# CHANGE ORDER

City of Ramsey

21-08

Water Treatment Plant Trunk Water Main Improvements

**REMOVAL PLAN  
TOWN CENTER DRIVE**

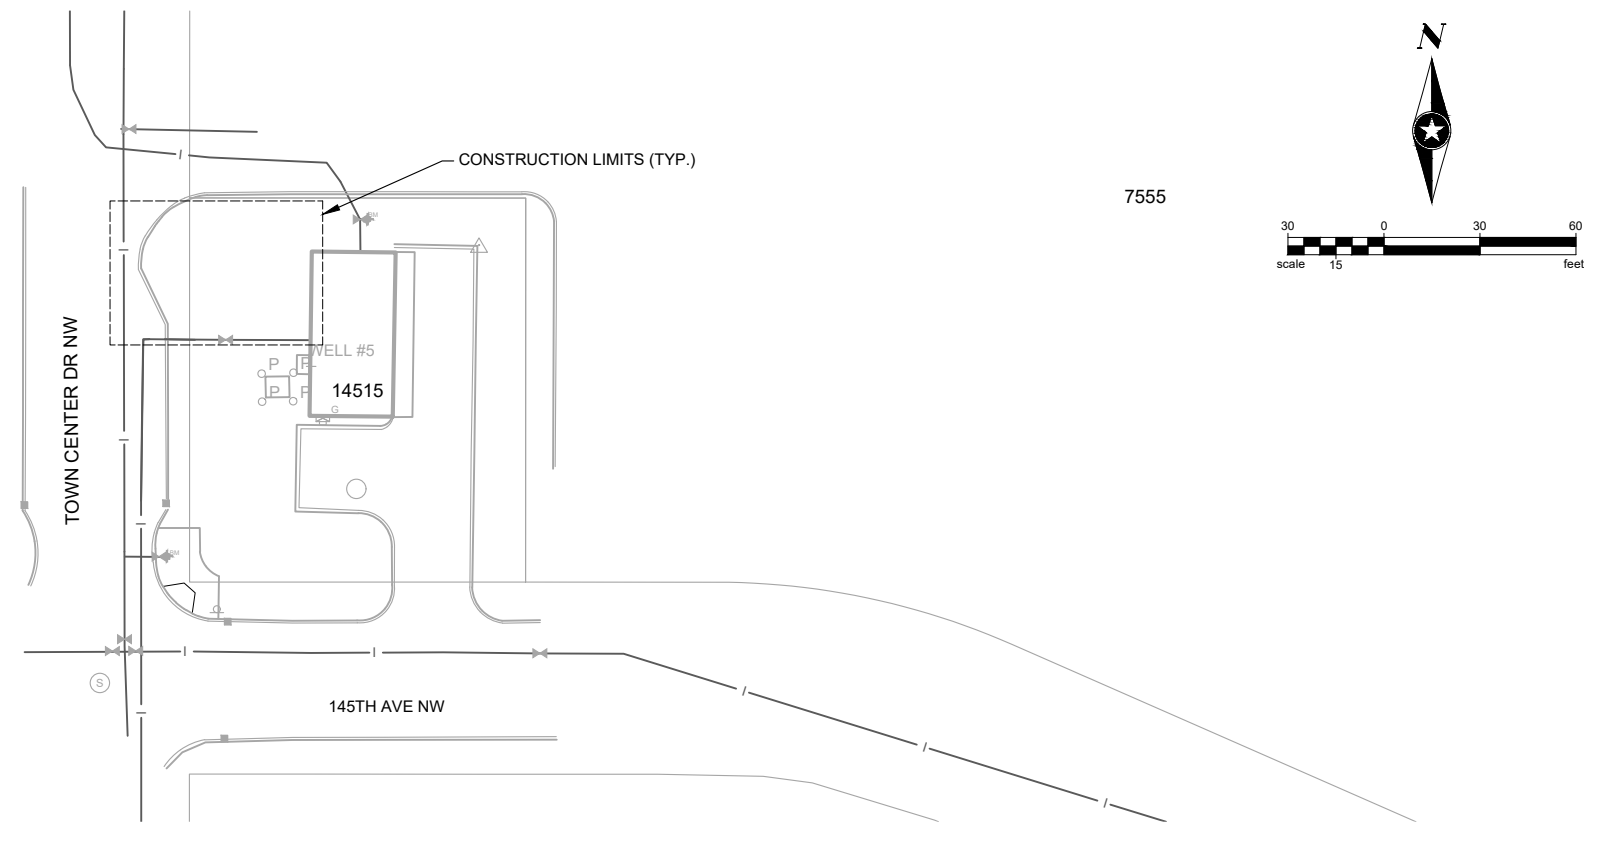
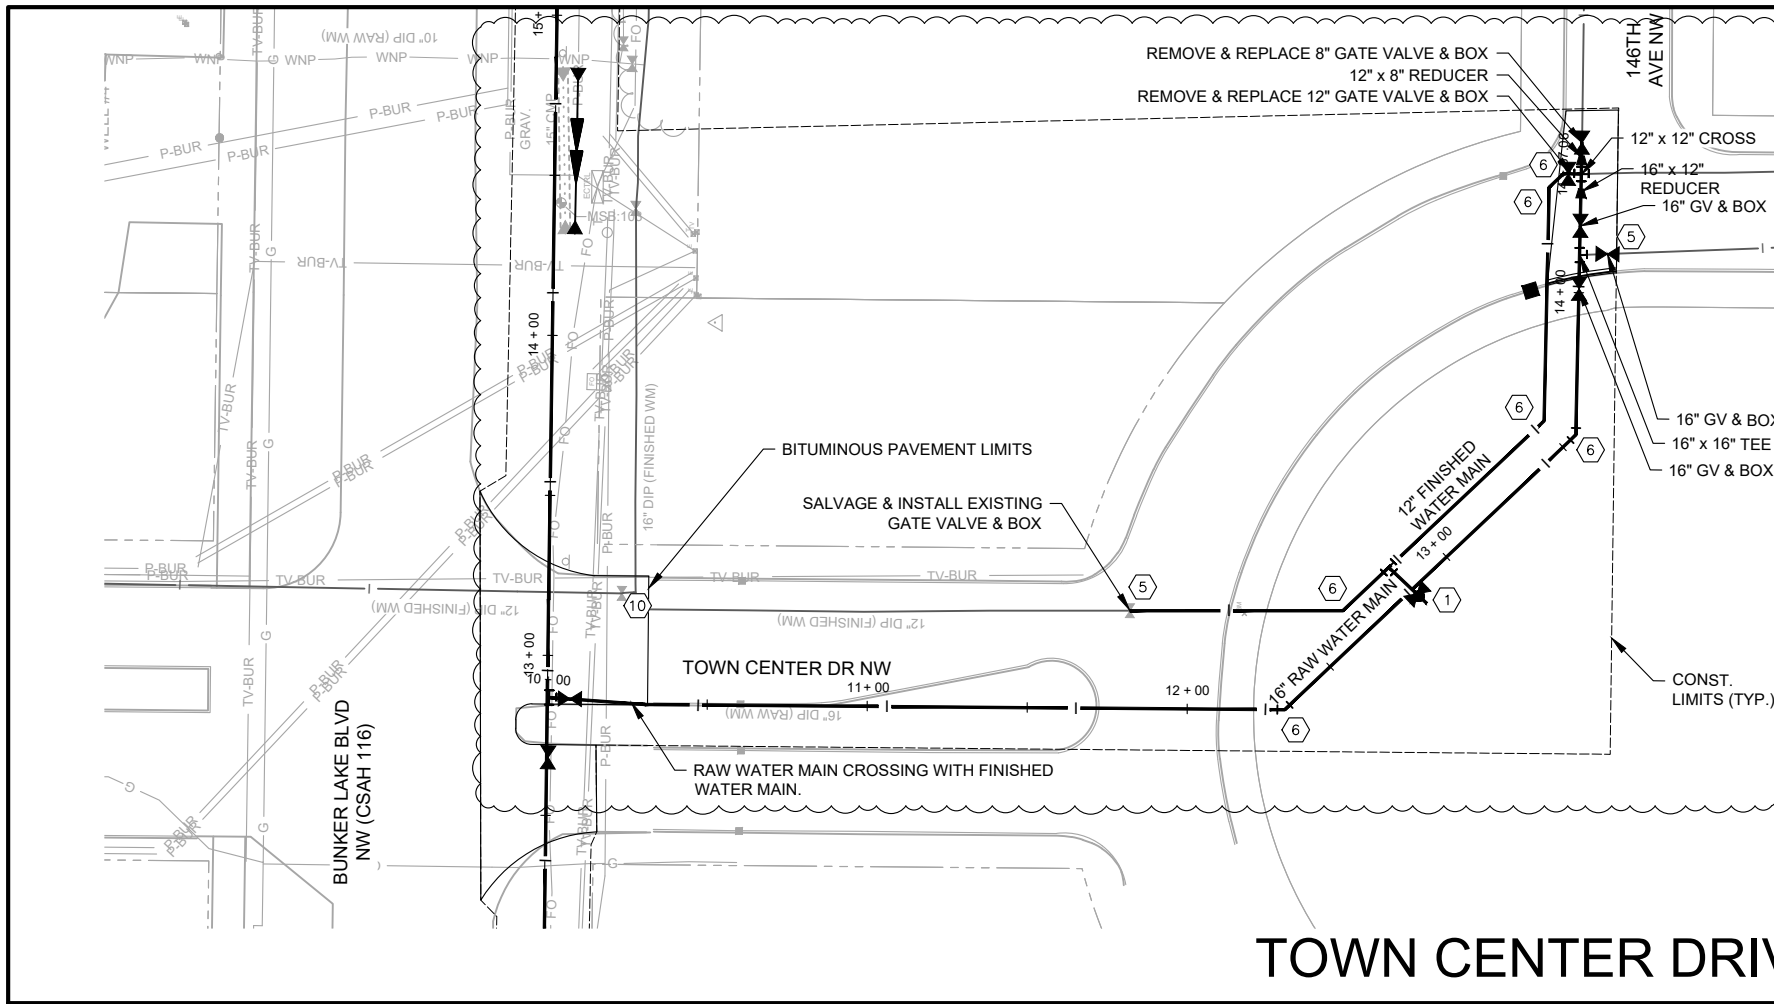
Removal and replacement of 12" water main, fittings and hydrant on Center Street and increase quantity for placement of new 16" water main and fittings.

SEH Project	RAMSY174498	Rev.#	Revision Issue Description	Date
Drawn By	JRB, SRP	.		
Designed By	KLK	.		
Checked By	CES	1	FIELD DESIGN REVISION	04/26/2024

**UTILITY PLAN AND PROFILE**  
**TOWN CENTER DRIVE**

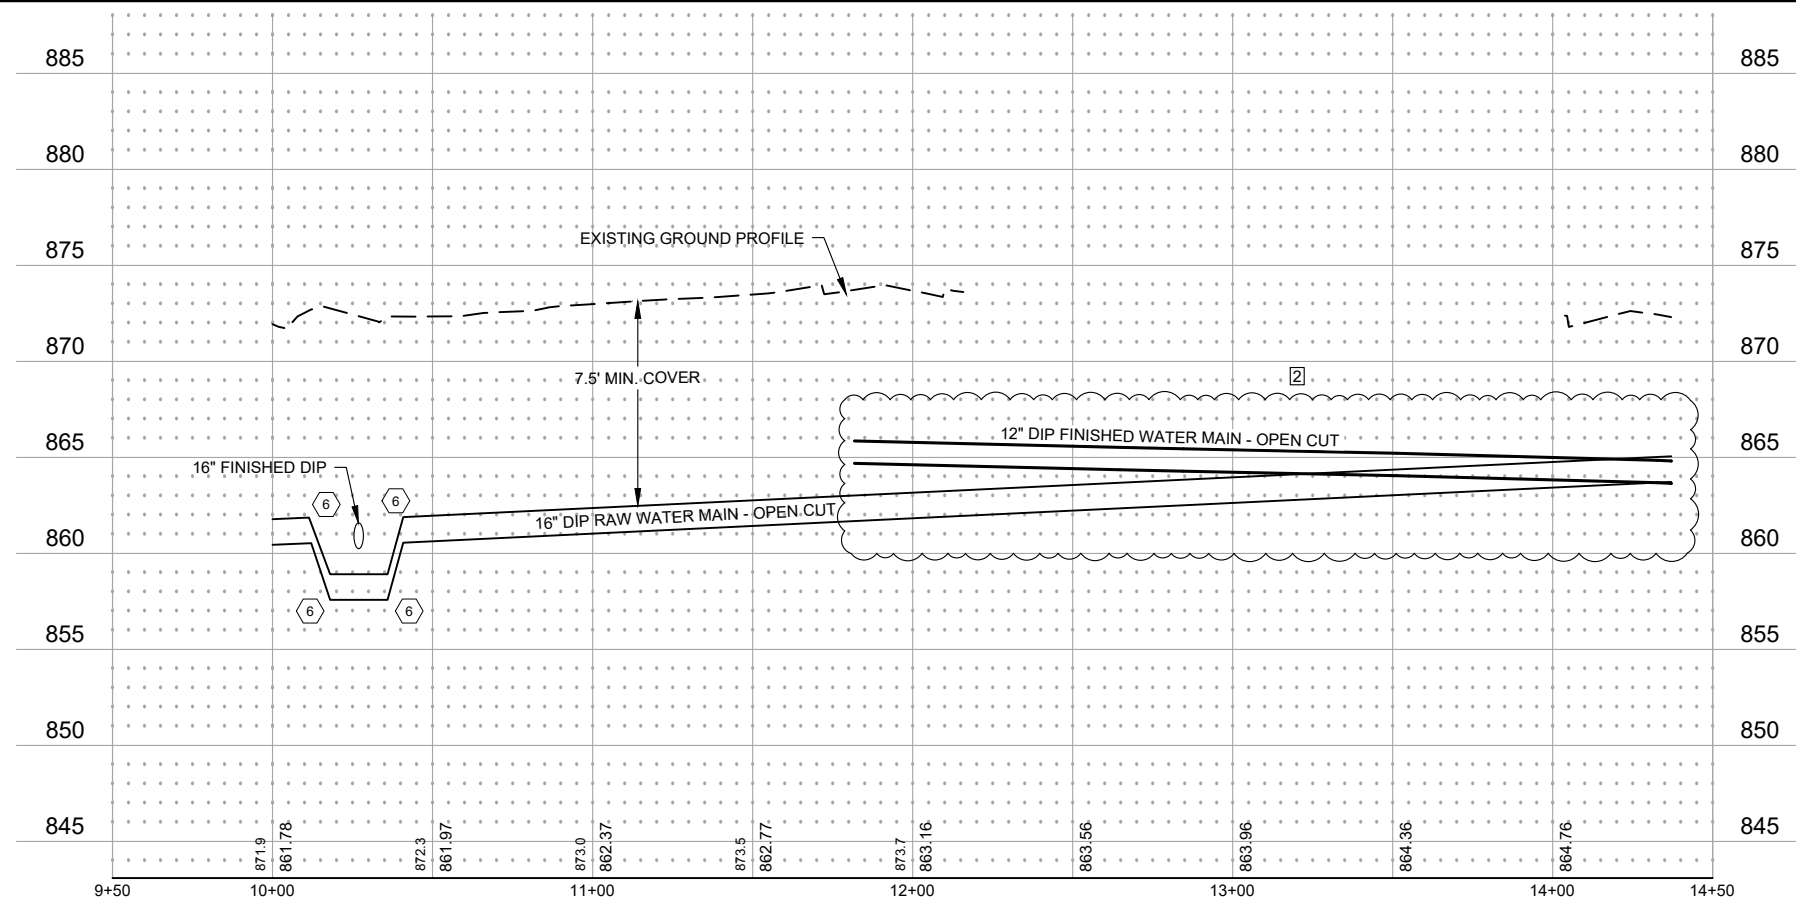
SEH Project	RAMSY174498	Rev.#	Revision Issue Description	Date	Rev.#	Revision Issue Description	Date
Drawn By	JRB, SRP	.			.		
Designed By	KLK	2	FIELD DESIGN REVISION	04/26/2024	.		
Checked By	CES	1	ADDENDUM #2	10/27/2023	.
